**re:** **Grading and Site Servicing Plans Review**  
**Proposed Residential Development**  
222 Baseline Road – Ottawa, Ontario

**file:** PG6324-MEMO.01

Further to your request and authorization, Paterson Group (Paterson) prepared the current memorandum to provide a review from a geotechnical perspective for the grading and site servicing plans for the proposed residential building at the aforementioned site. This memorandum should be read in conjunction with Paterson Geotechnical Report PG6324-1 dated September 23, 2022.

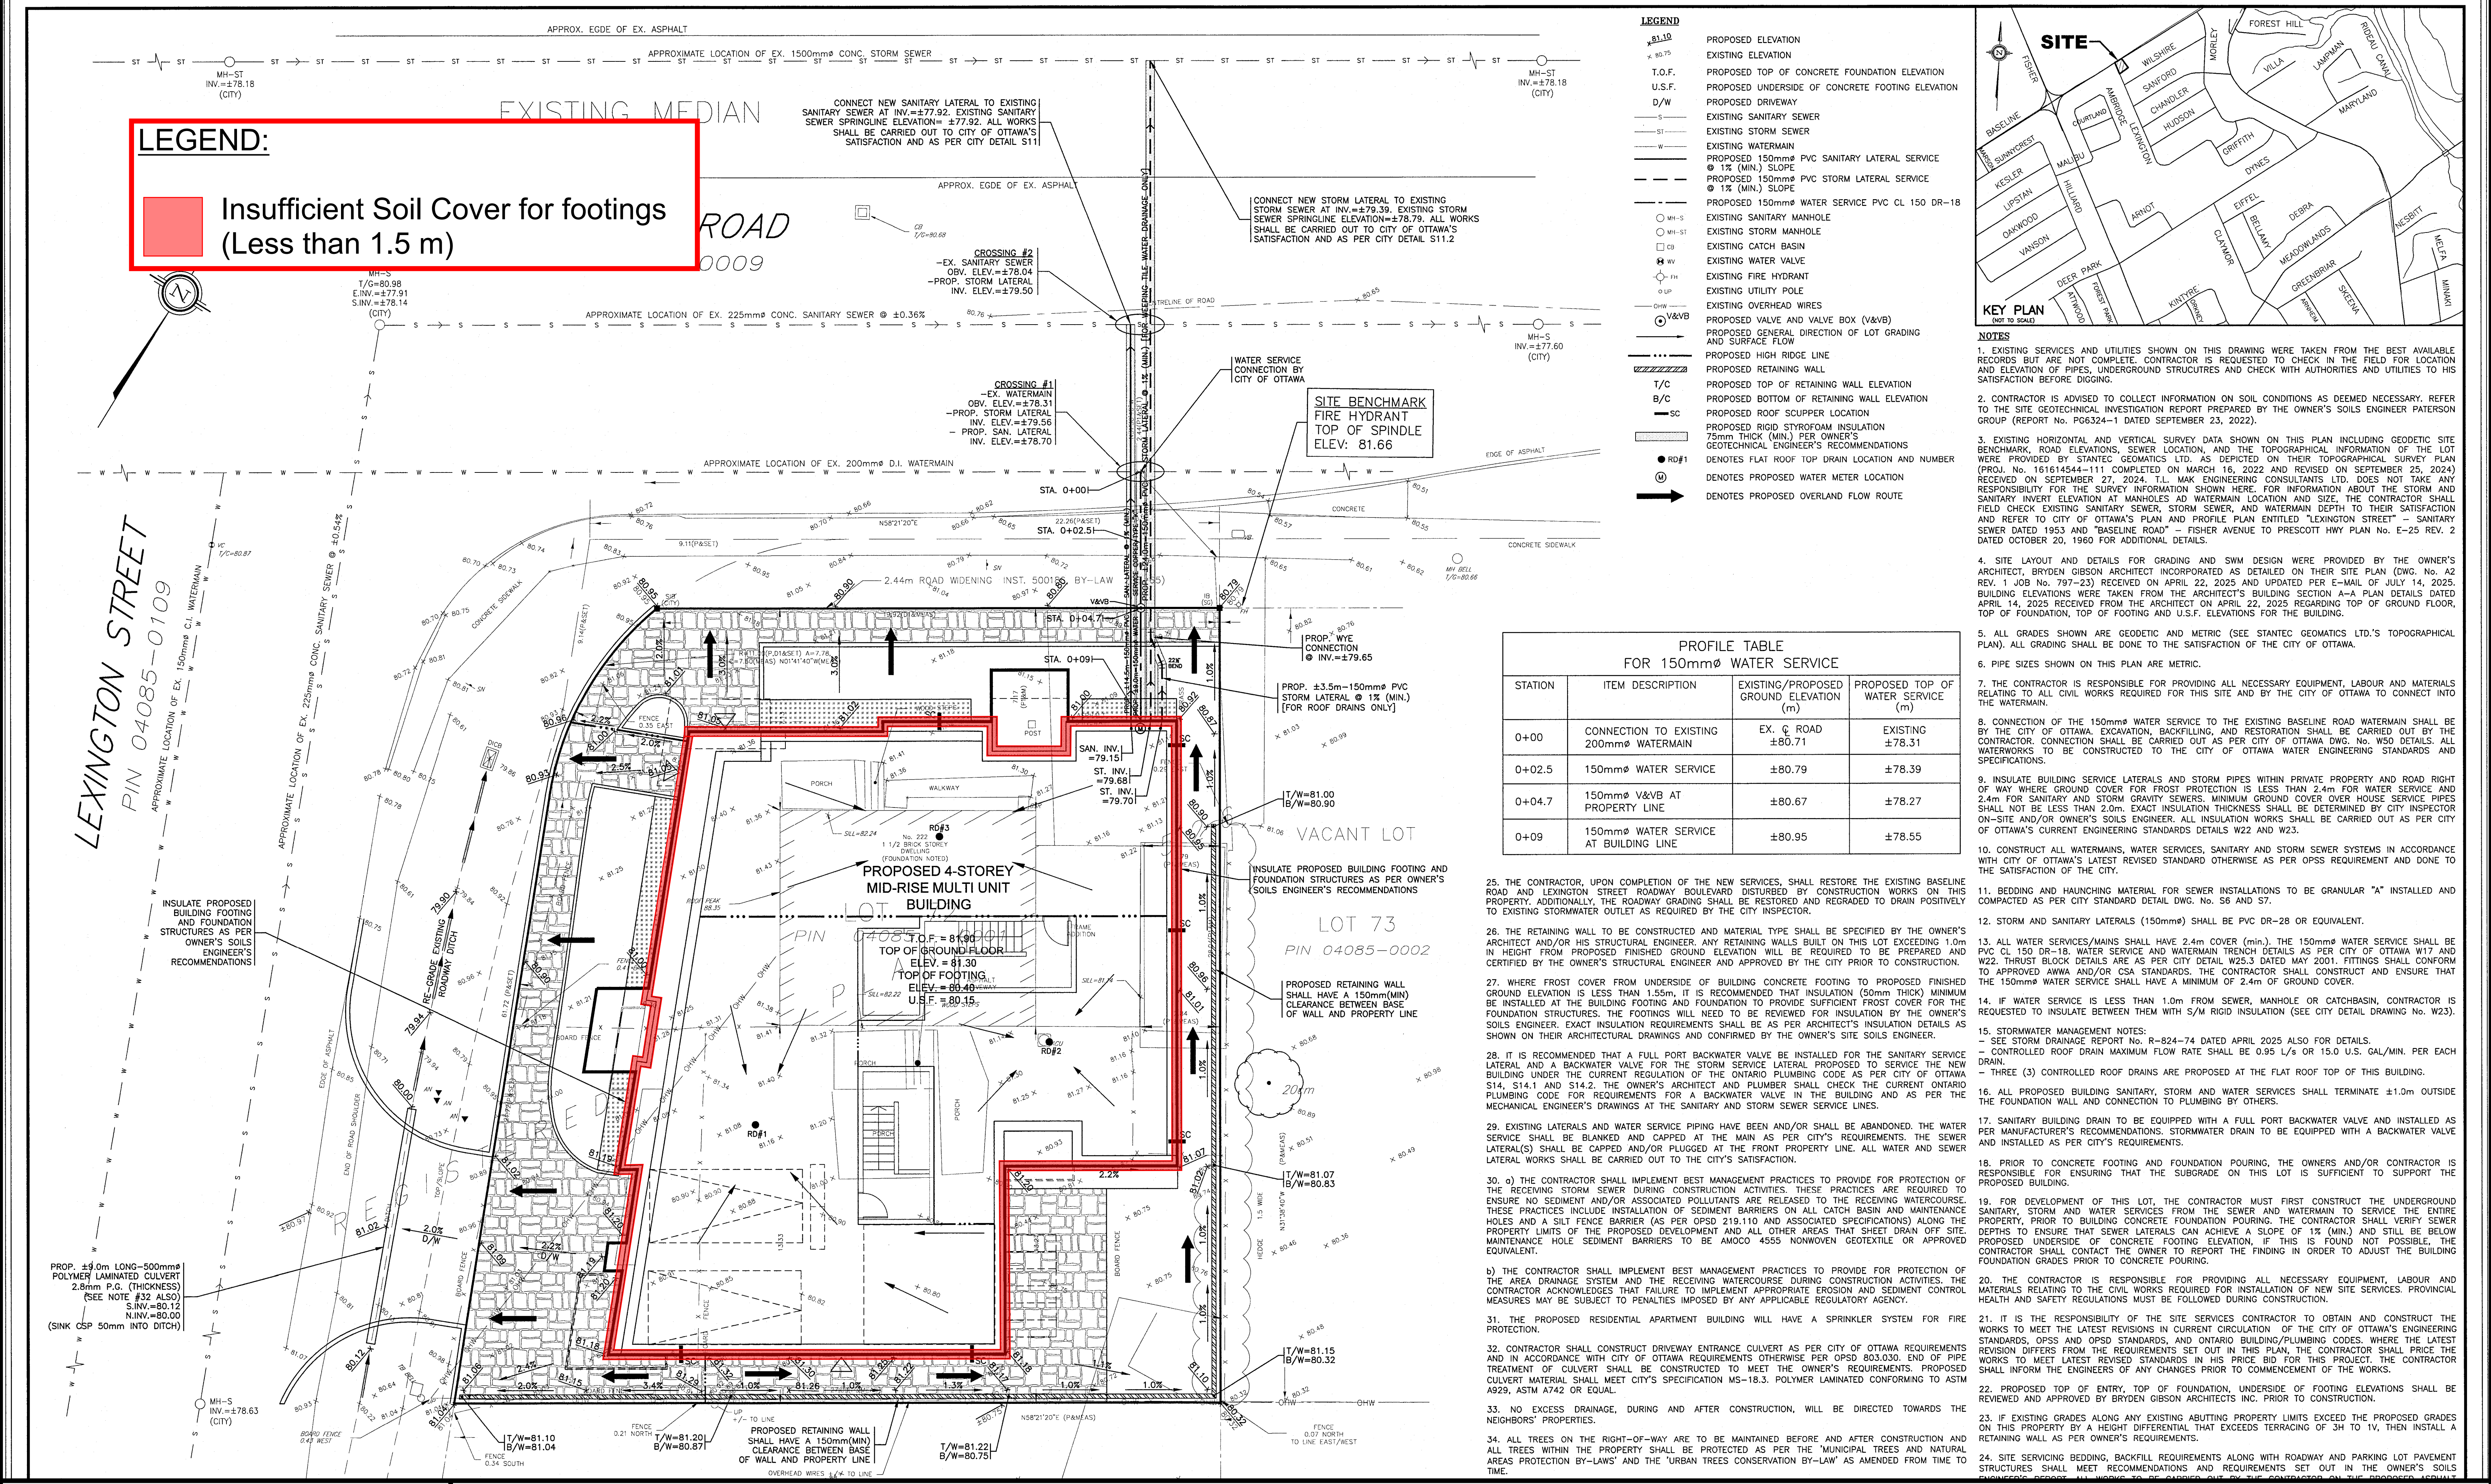
Based on our review of above noted grading plan, the perimeter footings for the proposed development are not provided with sufficient soil cover for frost protection. Therefore, rigid insulation will be required. Reference should be made to Figure 1 – Insufficient Soil Cover (Footings), attached to the current memorandum.

To accommodate insufficient soil cover for the proposed footings, rigid insulation is required to achieve adequate frost protection. Rigid insulation recommendations are presented in Table 1 on the following page.

All rigid insulation placed below the footings should consist of either Dow Chemical High-Load 40 (HL-40), Styro Rail SR.P400, or equivalent approved by Paterson. The rigid insulation placed below the footings should extend a minimum of 100 mm beyond the exterior edge of the footing. Styrofoam (SM) rigid insulation can be used beyond to extend beyond the footing face (above USF). Reference should be made to Figure 3 – Typical Rigid Insulation Detail, attached to this memorandum.

**Figure 2 - Insufficient Soil Cover (Services)**

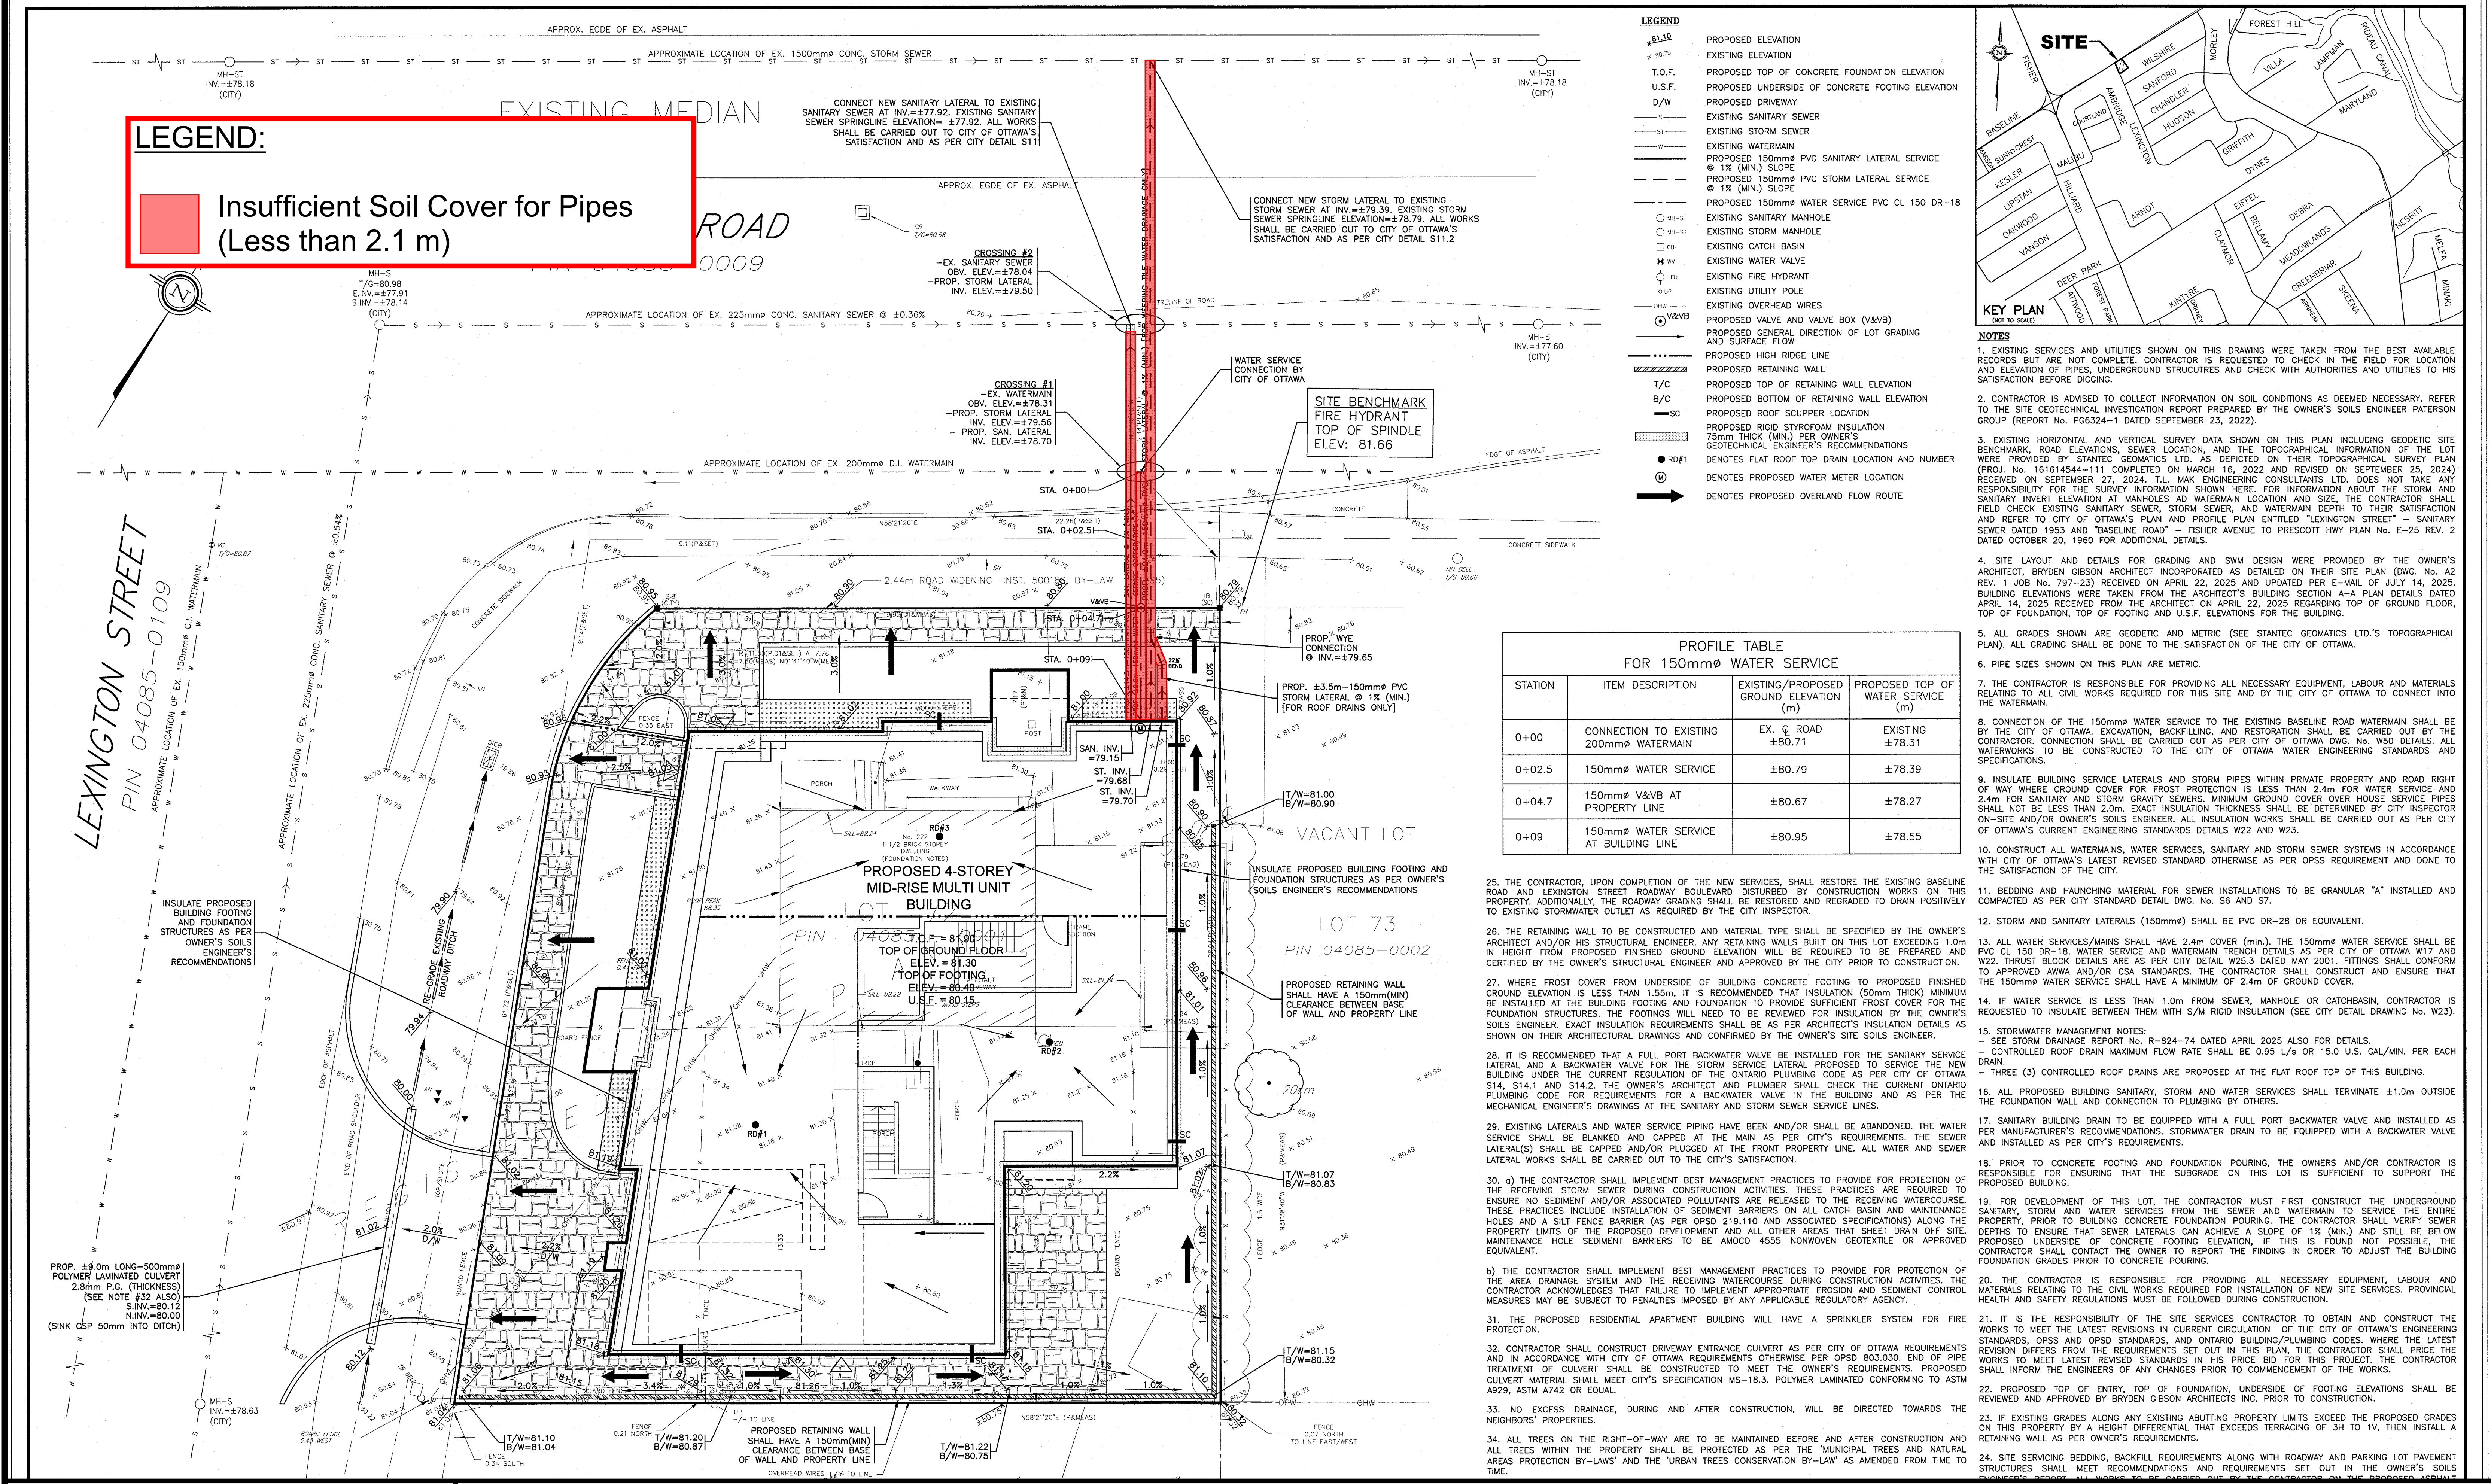
Insufficient frost protection has been provided for some of the proposed sanitary and storm sewer pipes throughout the subject site. Reference should be made to Figure 2 – Insufficient Soil Cover (Services), attached to the memorandum.

The sanitary and storm sewer pipes outlined on the above-noted figure are located within the frost zone of 2.1 m below the finished grade. Rigid insulation to provide adequate frost protection of the site servicing is recommended where insufficient frost cover has been provided. Any portion of the services installed at a depth of 2.1 m below the finished grade or deeper is considered to have sufficient soil cover for frost protection.

To accommodate insufficient soil cover for the proposed footings, rigid insulation is required to achieve adequate frost protection. Rigid insulation recommendations are presented in Table 2 on the following page.

All rigid insulation should consist of either Dow Chemical High-Load 40 (HL-40), Styro Rail SR.P400, or equivalent approved by Paterson. The placement of all insulation within the service trenches must be reviewed and approved by Paterson personnel at the time of construction. Reference should be made to Figure 3 – Typical Rigid Insulation Detail, attached to this memorandum.
